CJW Medical Center

Ref: Additional Information to License Amendment Request
License No. 45-15249-01
Docket No. 03008805
Mail Control No. 138361

Below is a response to each of the questions regarding our application for NRC licensure.

Radiation
Therapy

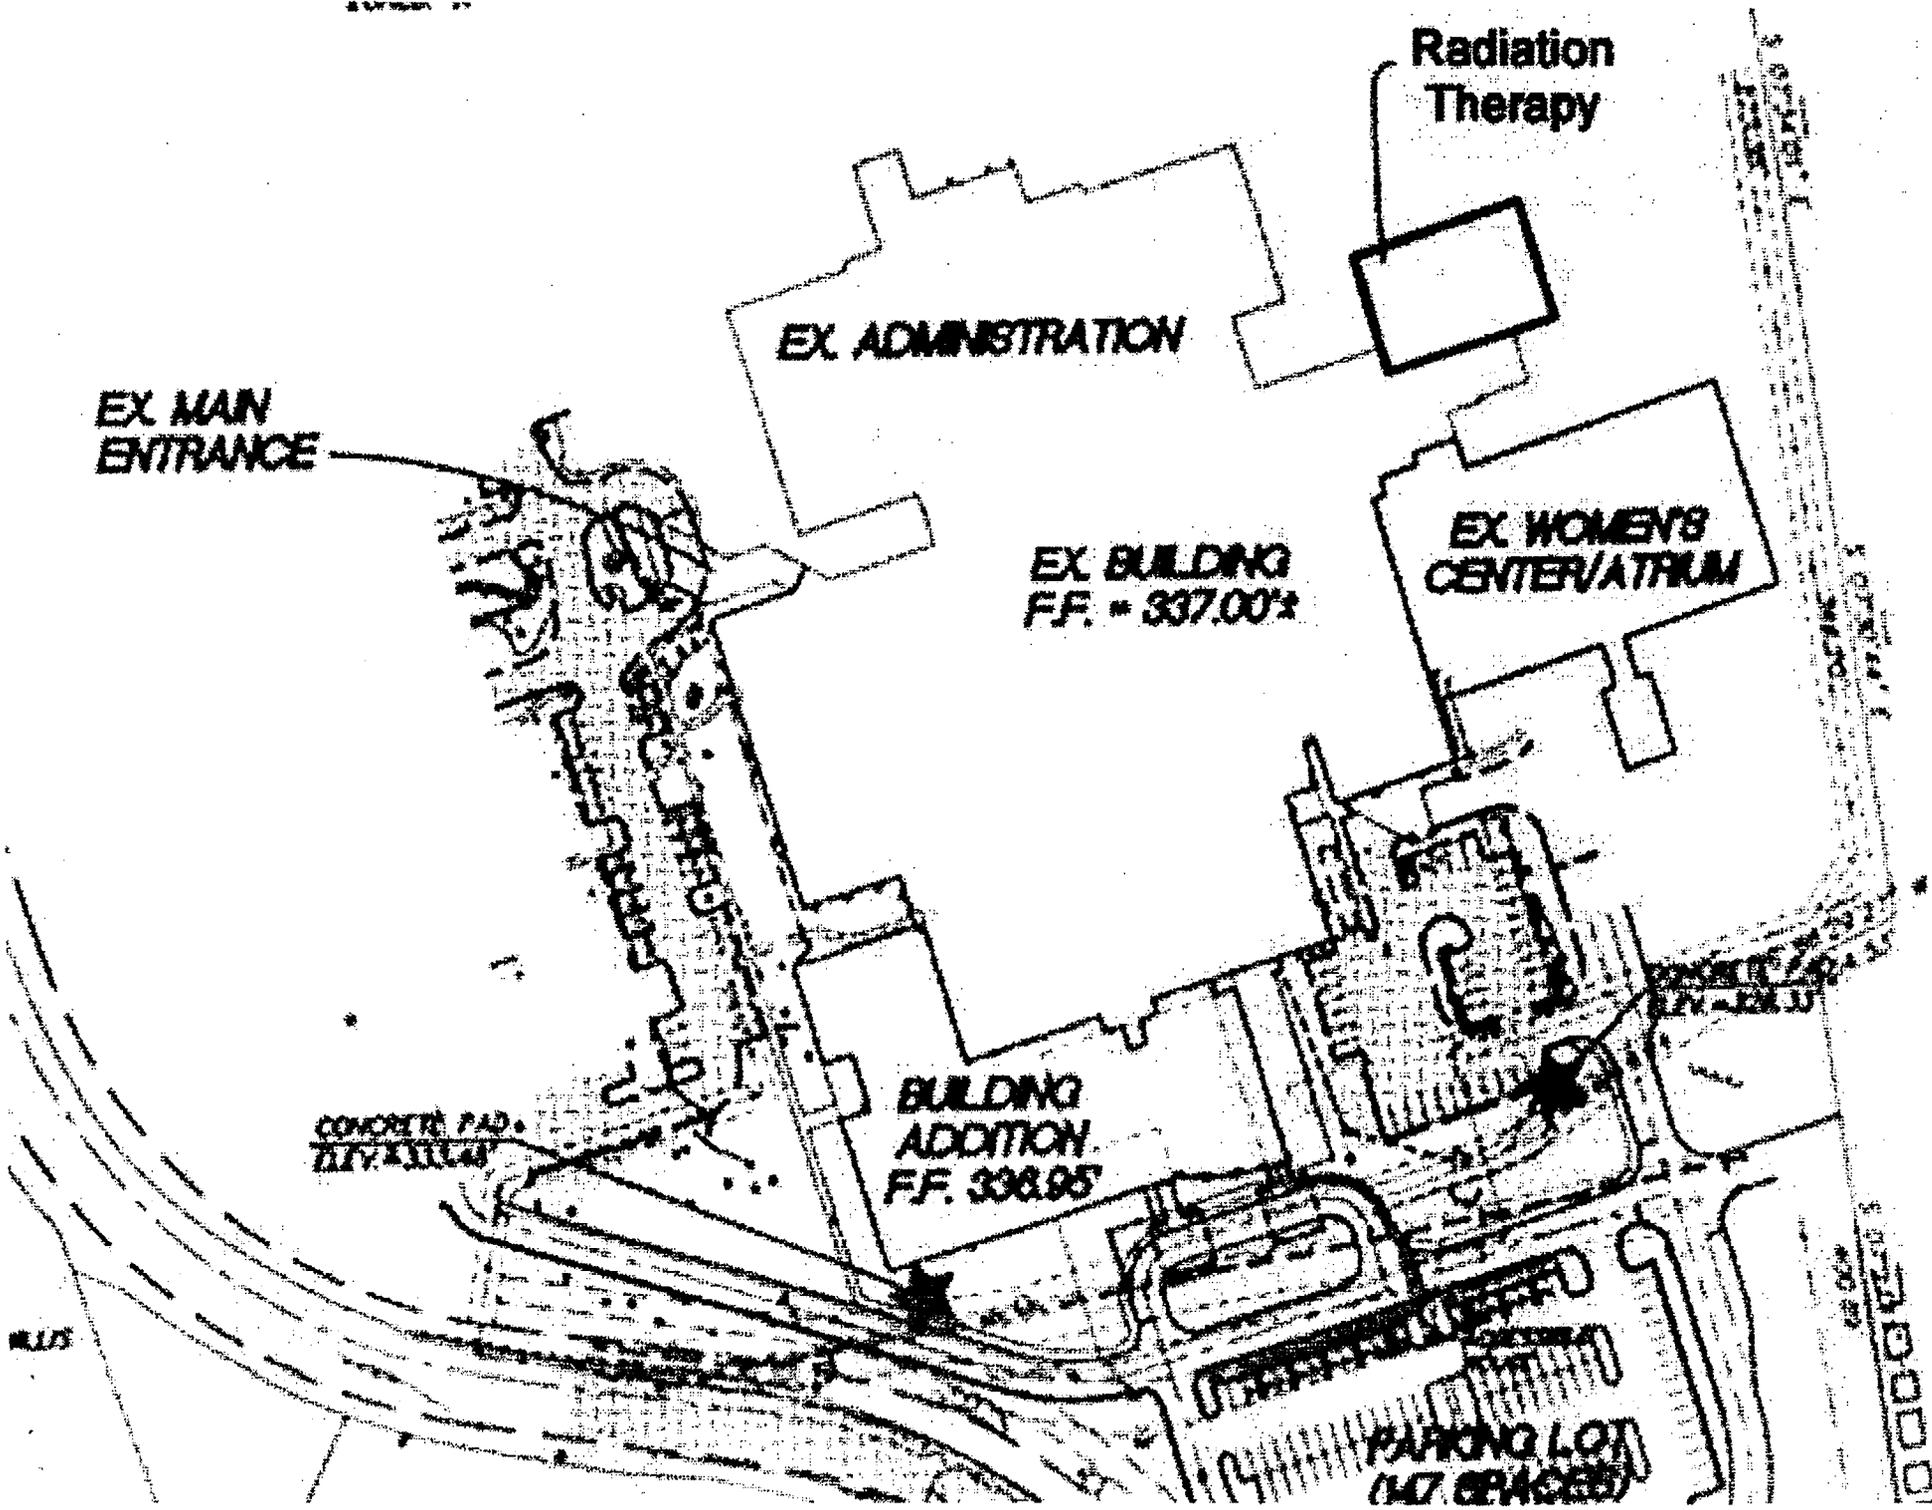
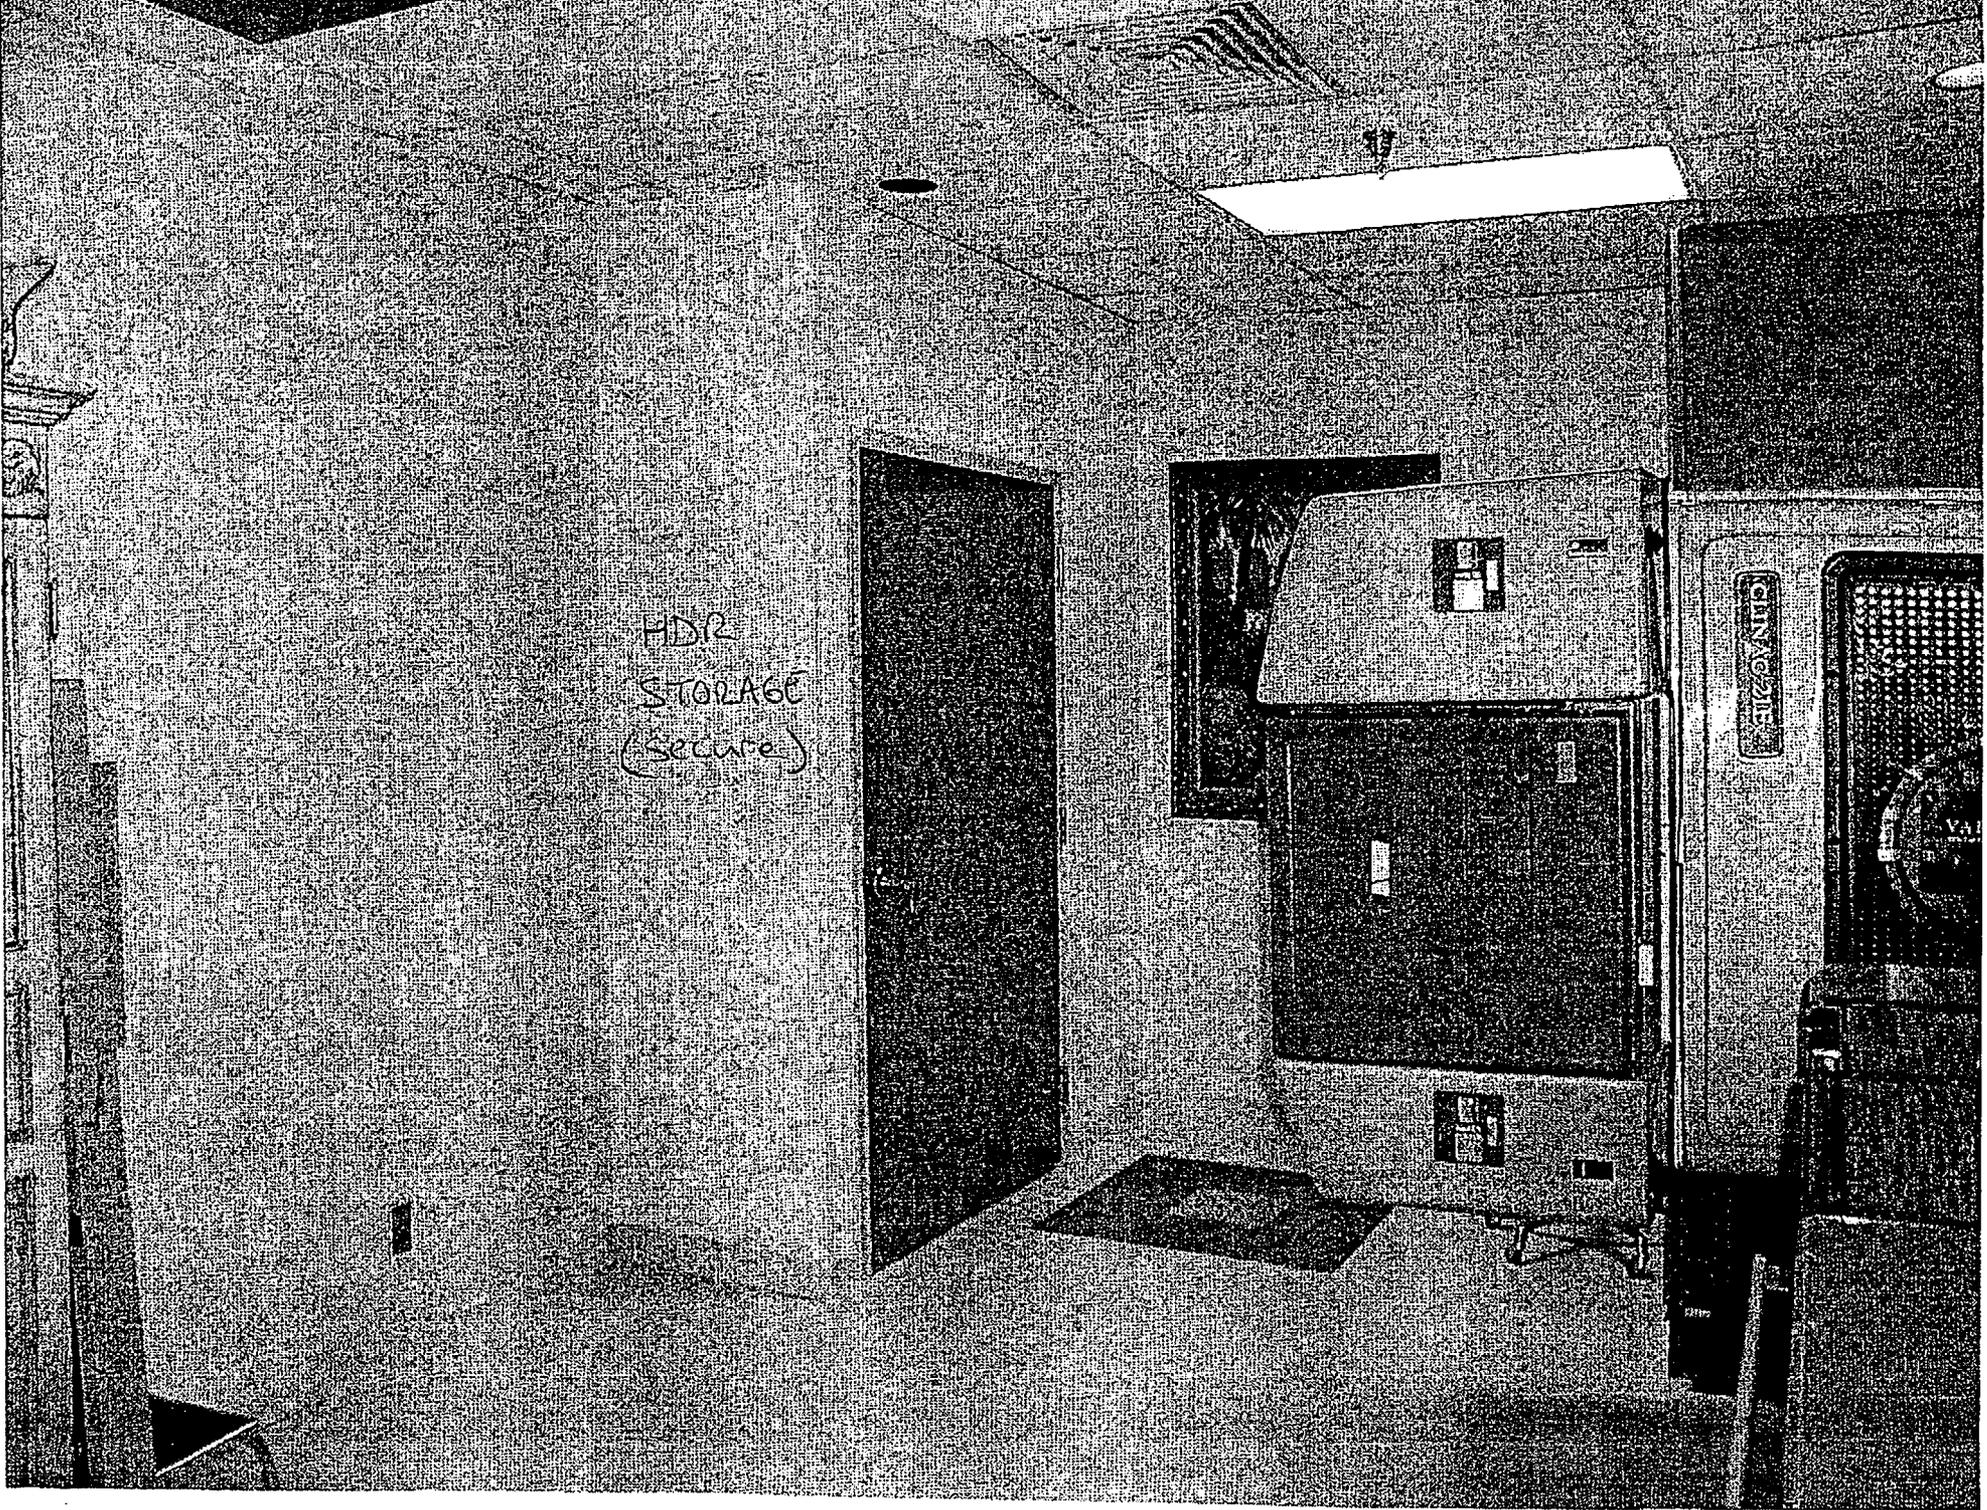
1. The diagrams submitted for the Johnston-Willis radiation therapy facility, Figure 1, and the High Dose Rate Remote Afterloader (HDR) treatment vault, Figure 2, are not legible. Please submit legible diagrams. In addition, for Figure 2, submit a diagram which is to scale, with the scale indicated, and which depicts the location and room number where the HDR unit will be used and stored. In addition, on this diagram (Figure 2), depict the locations, room numbers and principal uses of each area adjacent to the HDR treatment room.

Figure 1 was only intended to provide an approximate location for the Radiation Therapy Department location with respect to the main hospital building. Nothing more specific in terms of dimensions was intended. Though we have no way of knowing the condition of the transmittal to you, both diagrams were legible as prepared here. In particular, Figure 2 was identified as ATREATMENT BAY I-127, @ many dimensions including wall thicknesses were specifically indicated and there was a dimension scale indicated and located beneath the label, ATREATMENT BAY PLAN@ at the bottom of the diagram. To add more clarity, jpg image files for these two figures are attached. In this larger jpg image for Figure 2, 5 feet is equal to 3/4 inch on the diagram or 20 feet is equal to 3 inches on the diagram. The area adjacent to the west wall of the treatment is a ACONNECTOR@ (corridor) and the area adjacent to the north wall is a continuation of the CONNECTOR with the northeast corner as the control area for both the accelerator and HDR. The east wall is adjacent to a second treatment bay housing an accelerator of identical energies. The south wall is adjacent to a major electrical supply and electrical control room with very limited occupancy. The actual HDR unit will be stored in a closet in the southwest corner of TREATMENT BAY I-127. That closet is fitted with a lockable door as shown in the attached picture.
